**PLEASANT PRAIRIE PLAN COMMISSION MEETING
VILLAGE HALL AUDITORIUM
9915 39th AVENUE
PLEASANT PRAIRIE, WISCONSIN
6:00 P.M.
DECEMBER 9, 2013
AGENDA**

- A. **PUBLIC HEARING AND CONSIDERATION OF A CONCEPTUAL PLAN** for the request of Matt Phillips, agent for Senior Lifestyle Corporation for the proposed Senior Lifestyle Community that will provide 96 senior living dwelling units in phase 1 and 66 dwelling units in phase 2 on the vacant 9 acre property generally located south of Prairie Ridge Blvd. and east of 97th Court within the Prairie Ridge development.

CONSIDERATION OF A CONCEPTUAL PLAN for the request of Matt Phillips, agent for Senior Lifestyle Corporation for the proposed Senior Lifestyle Community that will provide 96 senior living dwelling units in phase 1 and 66 dwelling units in phase 2 on the vacant 9 acre property generally located south of Prairie Ridge Blvd. and east of 97th Court within the Prairie Ridge development.

1 PRELIMINARY LANDSCAPE PLAN
SCALE: 1" = 40'-0"

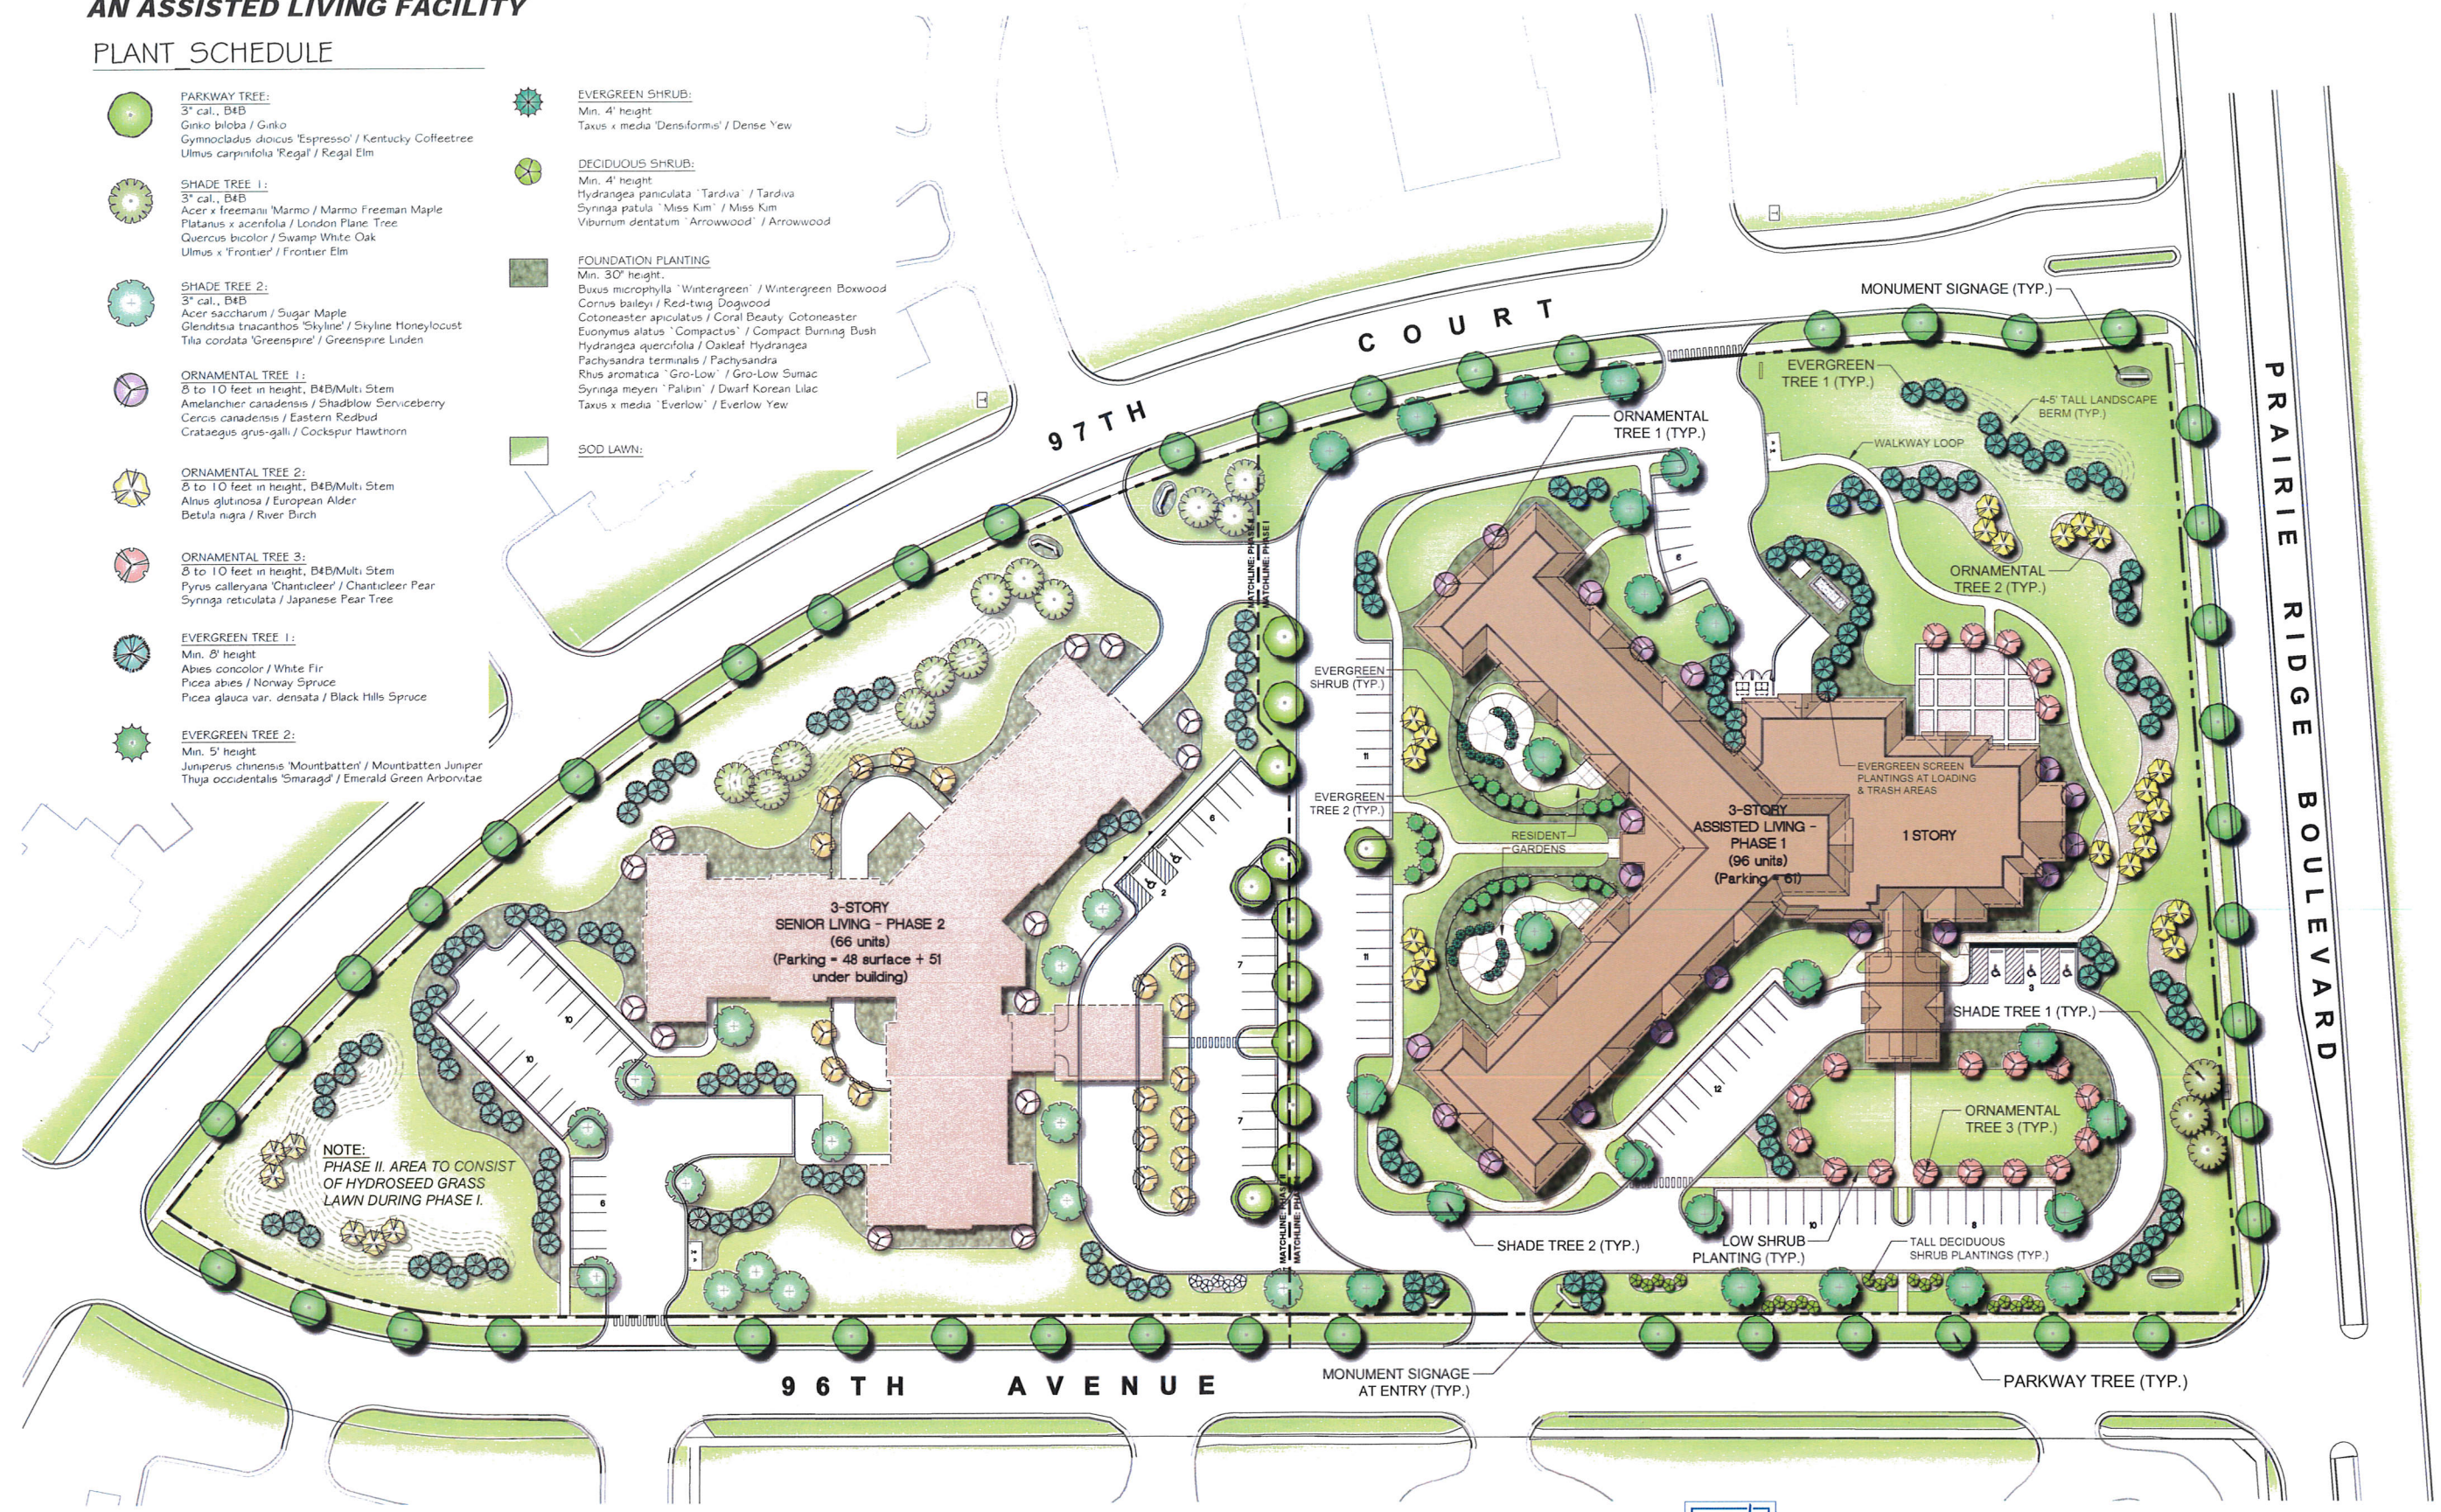
- f. Provide a chart on the plans that specify the square footage of each unit type.
- g. On **Sheet L1**, change notation of "Parkway Tree" to "Street Tree".
